> Watts Bar Nuclear Plant, Unit 2 NRC Docket No. 50-391

Subject: Watts Bar Nuclear Plant (WBN) Unit 2 – Response to Requests for Additional Information (RAIs) Regarding Generic Letter 2004-02, Potential Impact of Debris Blockage of Emergency Recirculation During Design Basis Accidents at Pressurized-Water Reactors (TAC No. MD6726)

# Response to RAIs Related to NRC's April 19, 2011 Letter

Figure 6-6: Test 4C Head Loss vs. Time

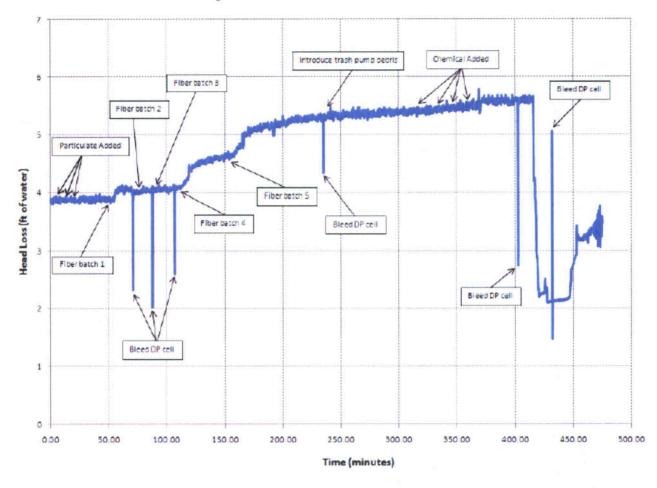
The application did not include a plot of the test strainer head loss as a function of time for the design basis test, annotated with significant events during the test, as described in the revised content guide for GL 2004-02 supplemental responses (ADAMS Accession No. ML07311 0278). The NRC staff reviews the plot to validate extrapolation of test results to the mission time, and to ensure that pressure-driven bed discontinuities did not affect the debris head loss (such that temperature scaling may be inappropriate). Provide an annotated plot of the design basis test.

The third Thin Bed Test was performed on July 16, 2010. This thin bed test represents the design basis test for WBN Unit 2 debris loaded head loss.

Figure 6-6 below from AREVA document number 66-9144025-000, Watts Bar Unit 1 Emergency Core Cooling System Strainer Performance Test Report, presents a plot of the head loss data versus time for the duration of Test 4C.

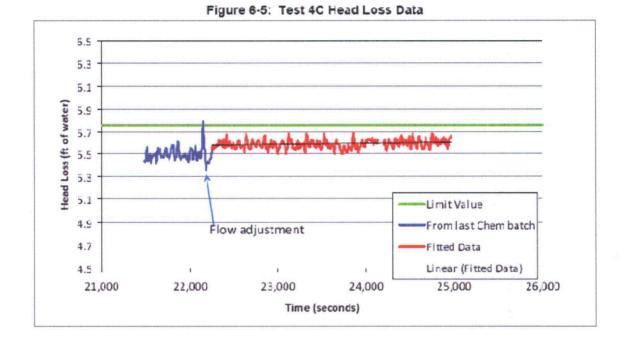
Provide the methodology used for extrapolation of head loss values to the 30-day mission time, including any statistical methodology employed.

Figure 6-5 below from AREVA document number 66-9144025-000, Watts Bar Unit 1 Emergency Core Cooling System Strainer Performance Test Report, presents a plot of the extrapolated head loss data versus time for the duration of Test 4C. As can be seen, the head loss after 15 flume turnovers is constant and therefore is bounding for the 30 day mission time.
